City of MISSION

PLANNING COMMISSION

AGENDA

STAFF REPORT
Planning Commission Meeting September 25, 2017

TRASH ENCLOSURE SECTION 12
SCALE: 1/2" = 1'-0"

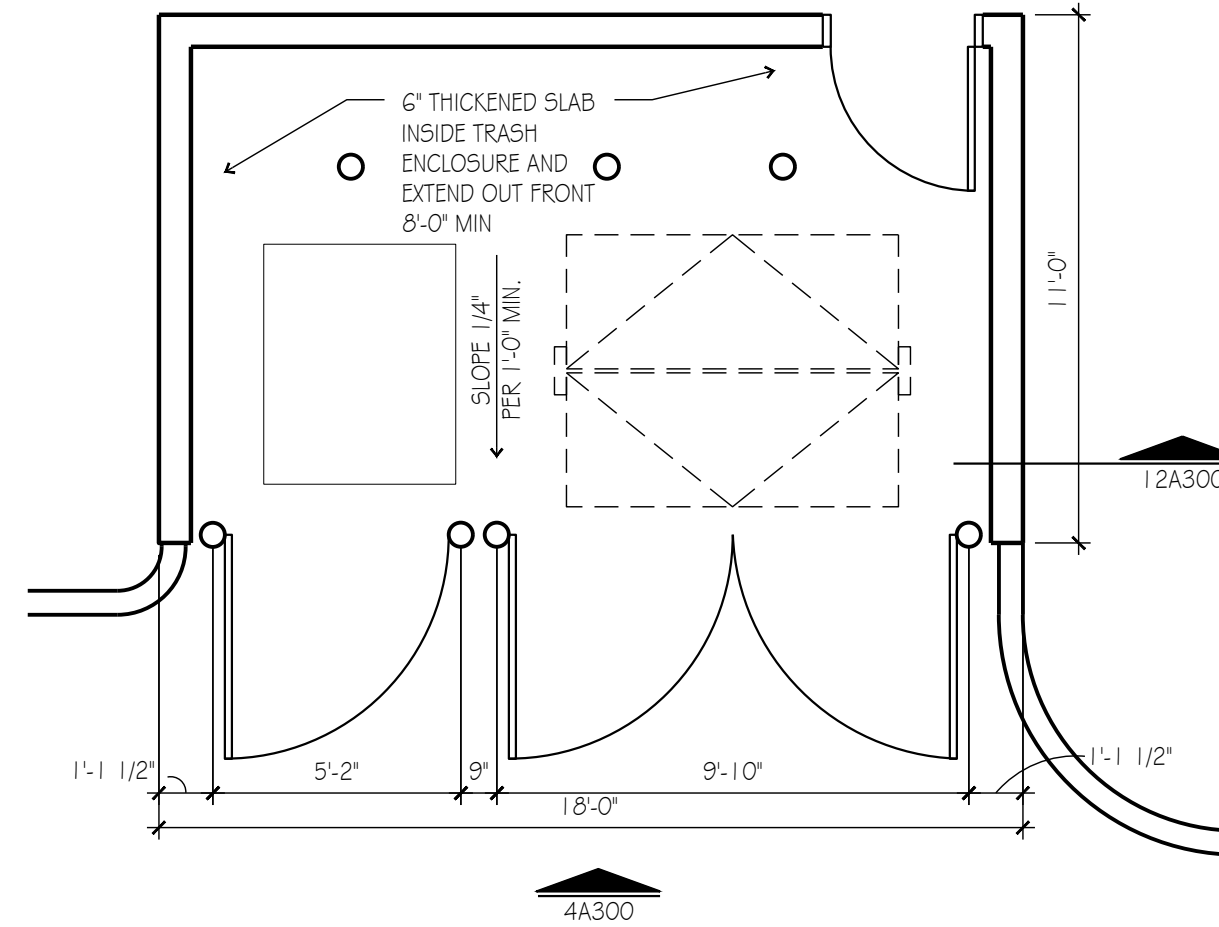
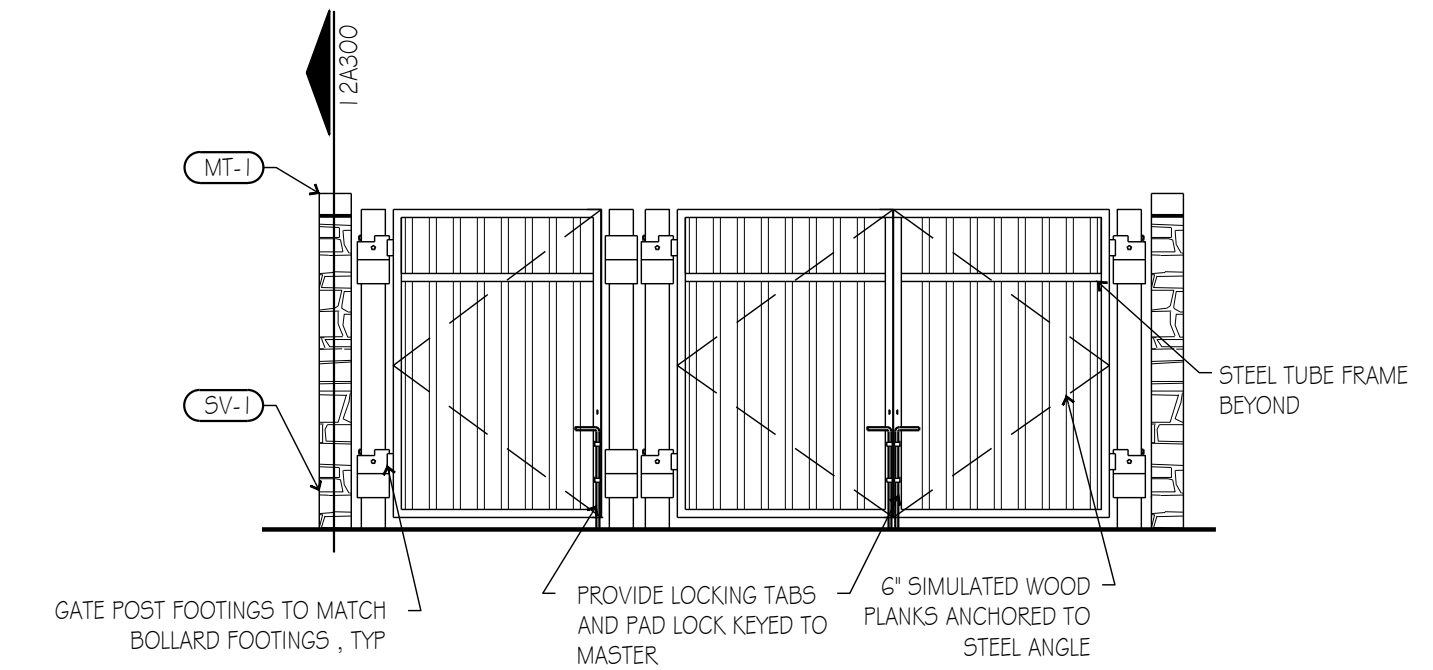
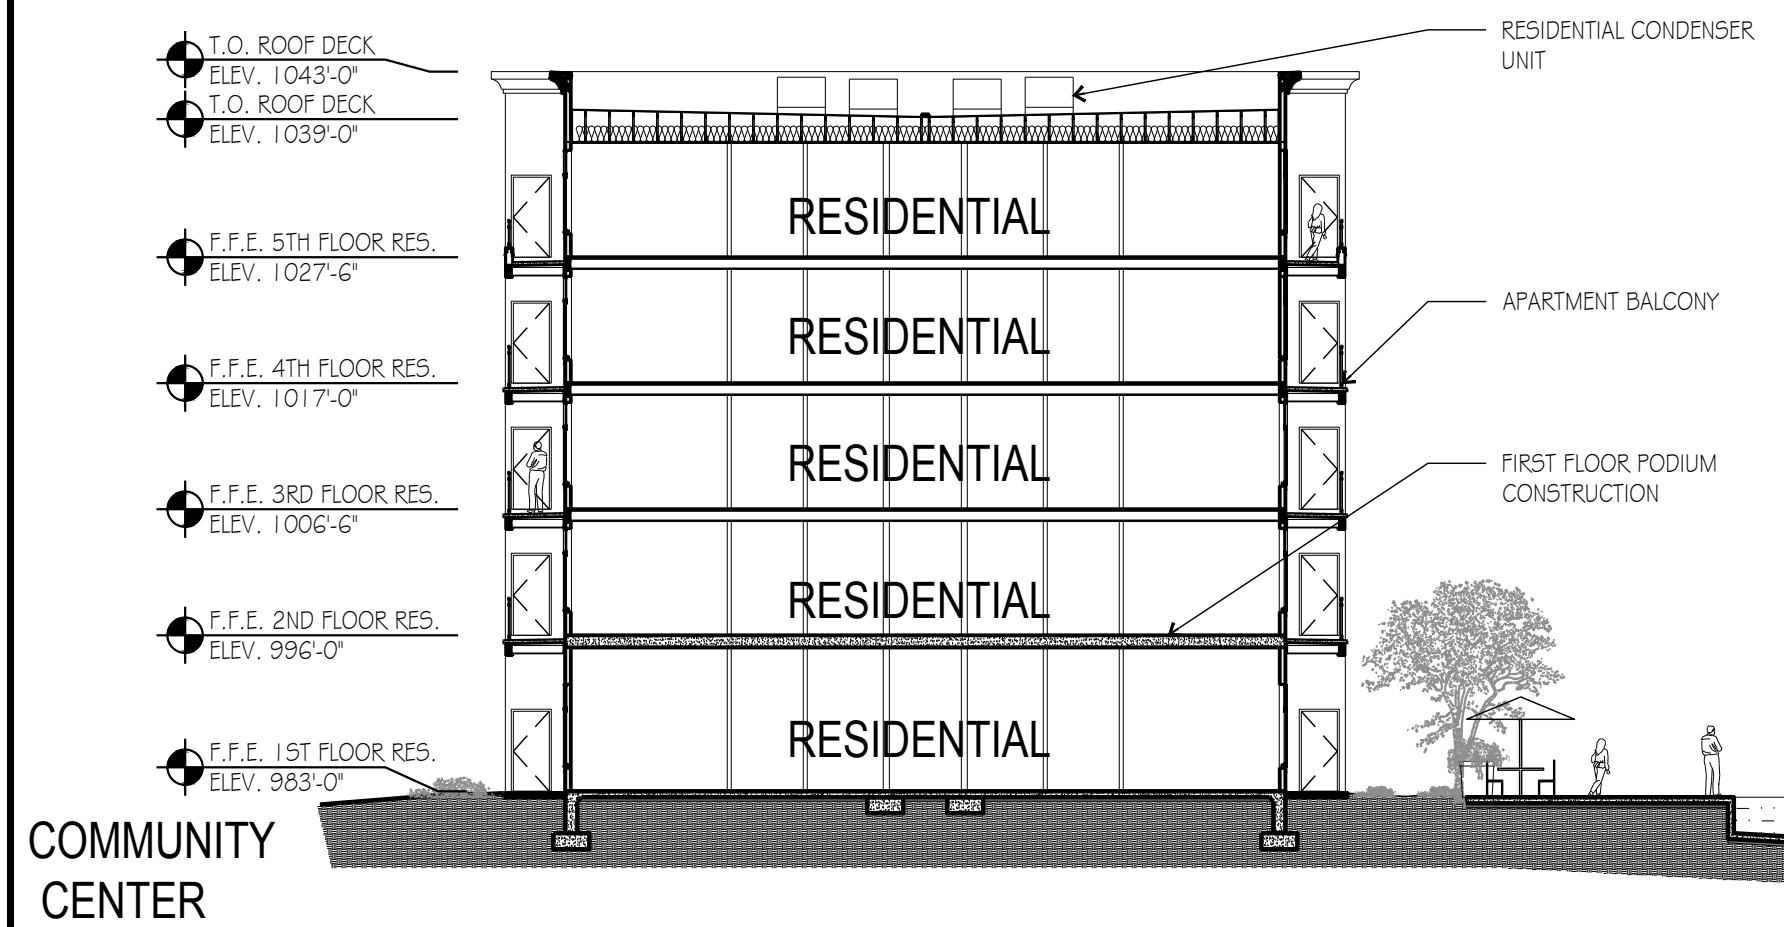
- *See revised sheet A300 details 4, 8 & 12.*
